UNITED STATES PATENT AND TRADEMARK OFFICE

APPLICATION NO.	FILING DATE	FIRST NAMED INVENTOR	ATTORNEY DOCKET NO.	CONFIRMATION NO.
10/816,650	04/02/2004	Sandra A. Strickland	52082/FLC/S1137	1055
23363	7590	03/21/2005	EXAMINER	
CHRISTIE, PARKER & HALE, LLP PO BOX 7068 PASADENA, CA 91109-7068			NGUYEN, TRINH T	
			ART UNIT	PAPER NUMBER

Office Action Summary	Application No. 10/816,650	Applicant(s) STRICKLAND ET AL.	
	Examiner Trinh T Nguyen	Art Unit 3644

FIG. 3

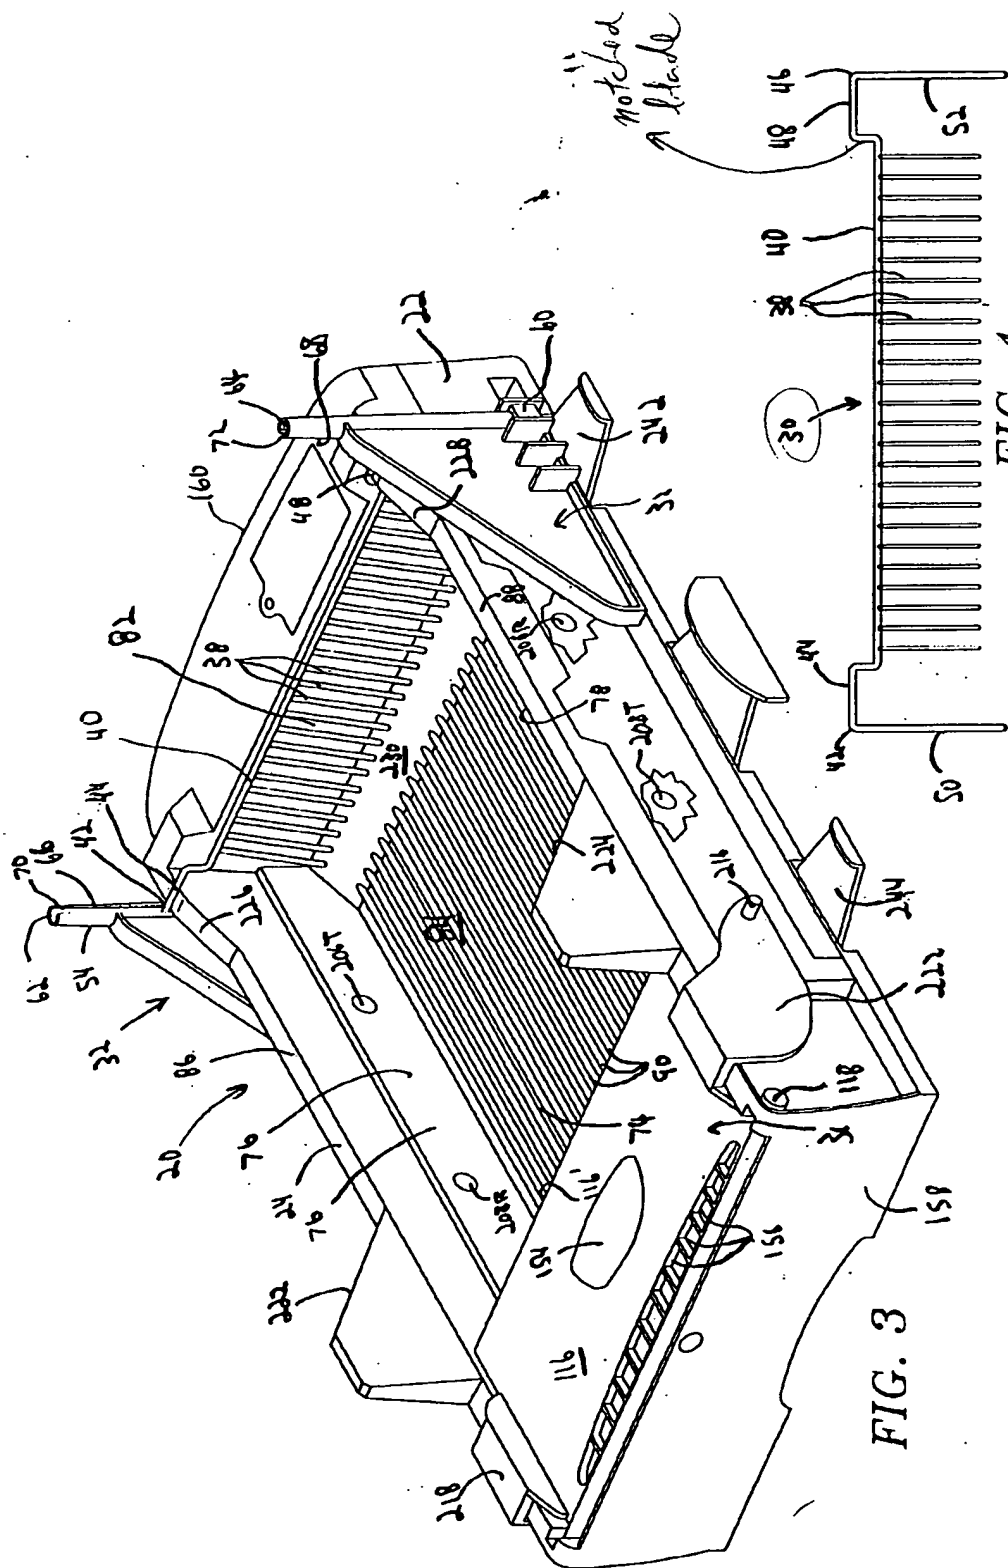
For claim 1, US'700 discloses an enclosed litter box, comprising: a chassis (26); a removable litter tray (Figure 3) slidably coupled to the chassis; a manual rake (30) located within the removable litter tray; and an enclosure (28) mounted to the chassis enclosing the removable litter tray and rake.

For claim 8, US'700 discloses an enclosed litter box, comprising: a chassis means (26) for supporting the enclosed litter box; a slidably removable litter tray means (Figure 3) within the chassis means for holding litter; a manual rake means (30) located within the removable litter tray means for separating animal waste from the litter; and an enclosure means (28) coupled to the chassis means for enclosing the removable litter tray means and the rake means.

FIG. 4

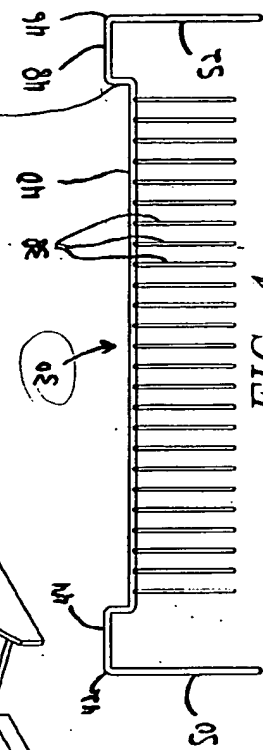
For claim 4, US'700 discloses the scoop further includes a notched blade (44) for engagement with a tined portion of the manual rake.

For claim 13, US'700 discloses wherein the scoop means further comprises a notched blade (Figure 4 attached at the end of this Office Action) for engagement with a tined portion of the manual rake means.
